Amendments to the Drawings:

R E M A R K S

FIG. 6

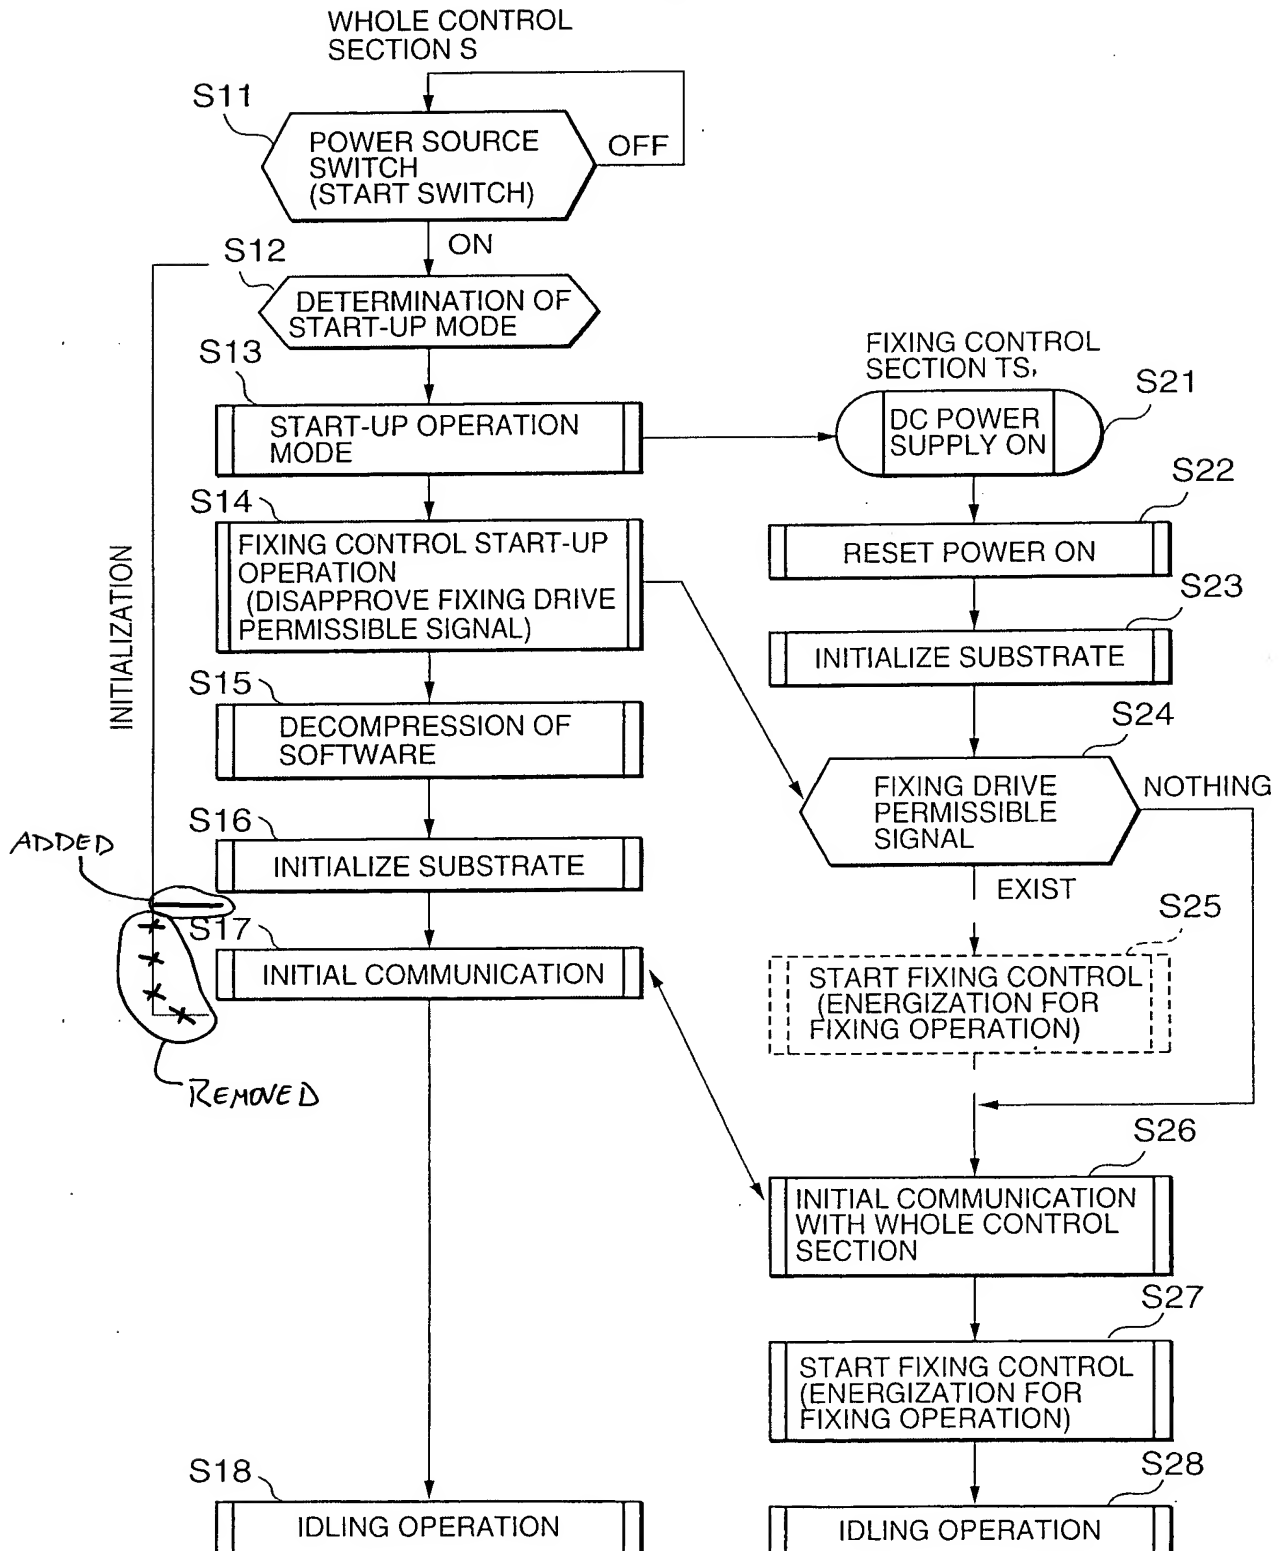
Figs. 6 and 7 have been amended to clarify that only steps S12-S16 (not step S17) are included in the "initialization," in accordance with the disclosure in the specification at page 22, lines 5 and 6.

Figs. 6 and 7 have been amended to clarify that only steps S12-S16 (not step S17) are included in the "initialization," in accordance with the disclosure in the specification at page 22, lines 5 and 6.
